SITE INSPECTION REPORT FOR A SEWAGE SYSTEM PERMIT

GU-5-03

County/City/Twp. Brillford Lot# 8 Conc.# 12

1. Assessment of Property

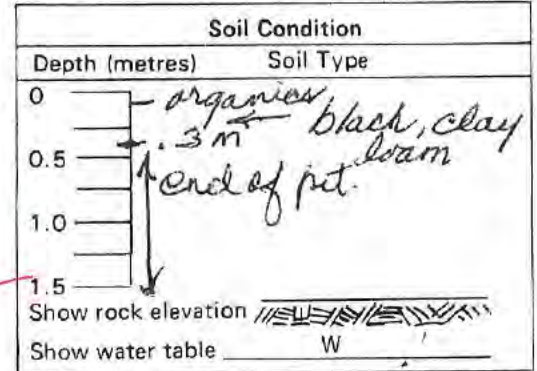
1. Ensure compliance w/ OBC, including additional setback of 2.4m added to all minimums.
2. Filter bed to be centered on test pit on high ground back 60+m towards W. sh. drive from turnaround area on lower side of drive.
3. Additional fill required to stabilize raised filter bed and create 4:1 mantle.
4. Specification sheet required for effluent pumps & alarm.
5. Aggregate sheet required for filter sand.
6. Filter bed to be raised 1.2 m above existing grade.
7. Filter bed to be split in two to create 2 beds each of 42m² with 68m² contact areas separated by 10m from each other.
8. Distribution box required to ensure each bed receives equal dose.
